### APPEAL SUMMARY

**Appeal ID:** 26355

**Project Address:** 6015 NE 42nd Ave

**LUR or Permit Application No.:** 21-077712-RS

*Sprinkler Appeal Proposal for  
6015 NE 42nd Ave*

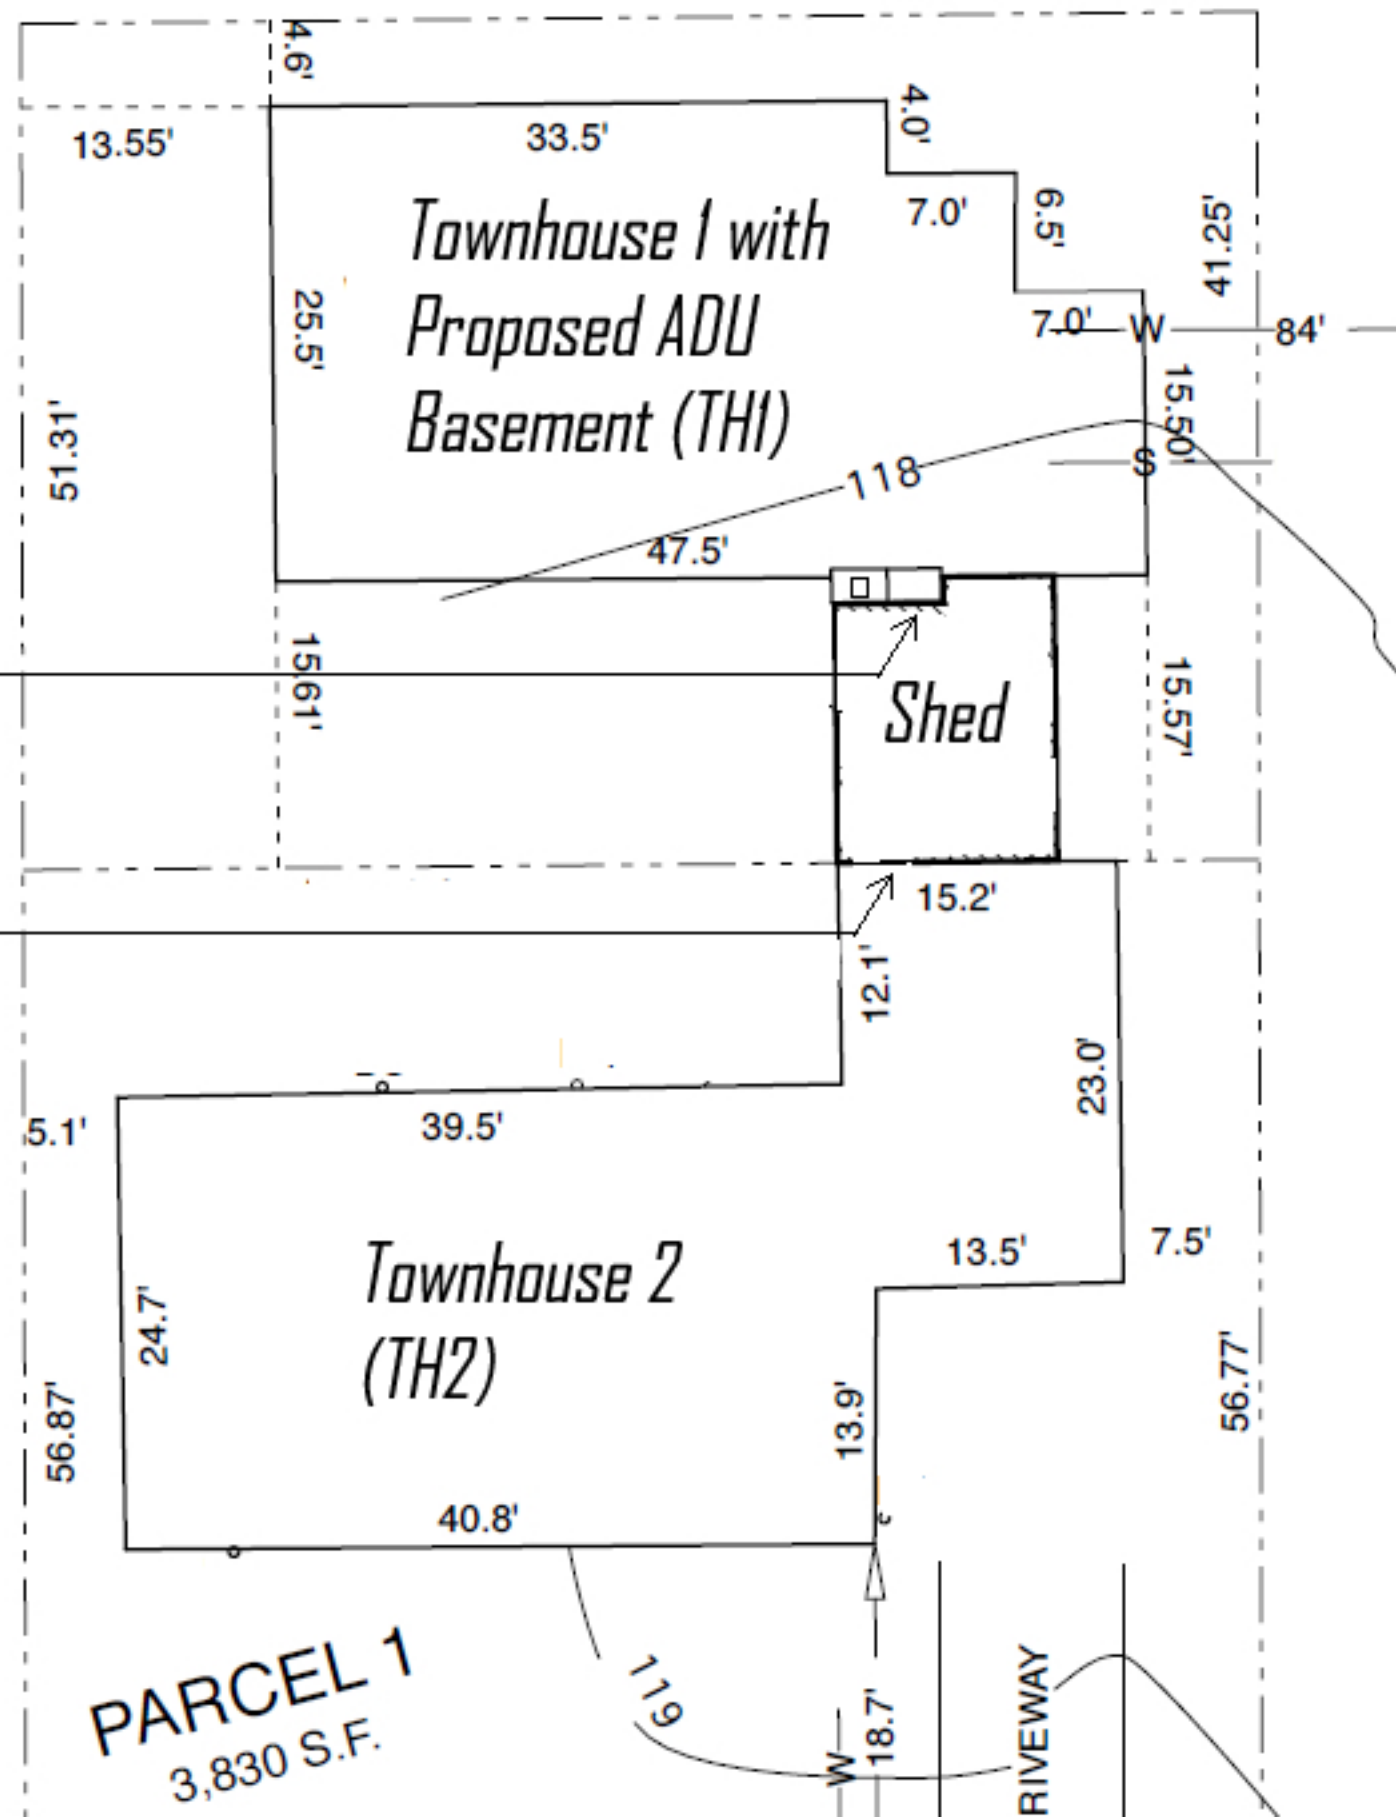
The proposed ADU is within a townhouse, but it is a non-traditional townhouse. The Townhouses are connected via a 15 foot wide shed, and there is an existing 2-hour fire rating where the shed connects the two homes.

Townhouse #1 (TH1) is connected to the townhouse #2 (TH2) with a 2-hour firewall between the two homes, via the shed connection to TH2. The shed is part of TH1.

Our proposal is to also add an additional 2-hour fire rating on the shed connection where the shed connects to TH1. This would provide an additional 2 hour fire rating to prevent fires from spreading from either house in either direction through the shed connection.

In addition to our original alternate method of adding an additional 2-hour fire rating between the two townhouses, we will also add a 1-hour firewall between the main unit and ADU to increase fire protection.

*Proposed additional 2 hour fire rating*

*Existing 2 hour fire rating*

**Omission of 13D sprinkler requirement in existing townhouse where new ADU is proposed: Granted provided Type 13D sprinklers are installed within the ADU portion of the townhouse on a separate permit through the Fire Marshal's office.**
